NUCLEAR ENERGY
ENGINEERING
DIVISION

Subject: Response to Recent Request for Additional Information -
General Electric Test Reactor - Docket 50-70

External Distribution
Response to 8 Structural Modifications Questions
of August 16, 1979

Photo #2. 3rd Floor Model (Bridge Assembly Perpendicular to Photo #1 Orientation)

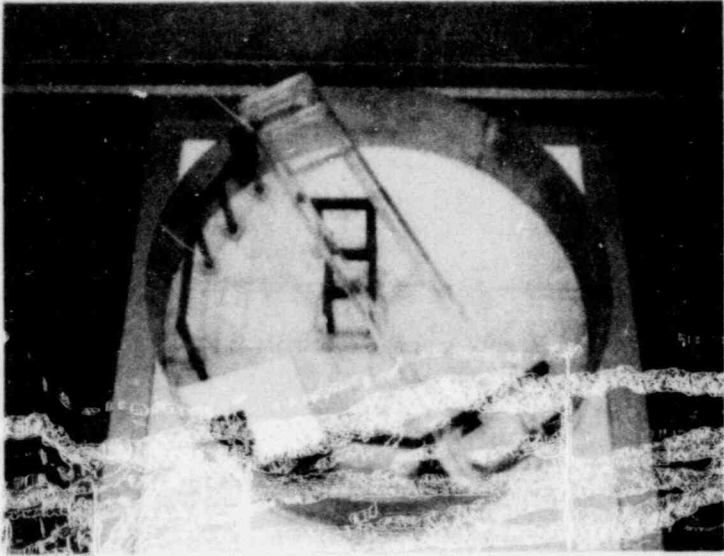
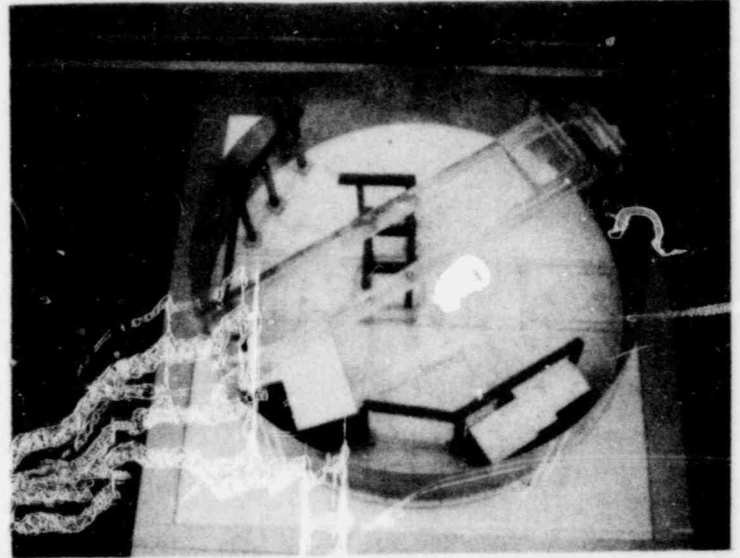
The calculation for the polar crane impact structures are for the end of the crane impacting the structure. In some conditions (perpendicular to the position shown in figure 2 of the document, "Structural Analysis of Third Floor Missile Impact System, General Electric Test Reactor") the polar crane would be supported by the structure over the reactor itself and then only on one side of the bridge girder. Also, the polar crane can be supported by only one bridge girder on bent 1. Provide your calculations to show the impact structures are capable of withstanding the impact of the polar crane for this condition.

If derailment/dislocation is postulated, one end of the polar crane bridge could lose support and drop until it impacts one of the polar crane impact structures, the 3rd floor elevator structure, or both. Because of the various configurations in which dislocation could be postulated, a scale model of the third floor area was constructed to carefully examine the reaction of the polar crane bridge assembly. Photo No. 1 shows the model as depicted in Figure 2 of Reference 5. The four structural bents (which comprise the polar crane impact structures), the elevator structure, the bridge crane and trolley are shown.

For most orientations the bridge assembly will not fall from the polar crane impact structures after the initial impact; however, there are some orientations where a subsequent fall is possible. The polar crane impact structures are designed to assure that these postulated fall trajectories are always away from the central core area of the reactor building. In this way, postulated missiles are directed away from any safety related items located on the third floor.

For example, Photo No. 2 shows the bridge assembly model rotated 90° from the position shown in Photo No. 1. In this rotated position, the west end of the bridge assembly is over both the elevator and bent no. 1, and the center of the bridge assembly is over the bent structure covering the missile shield
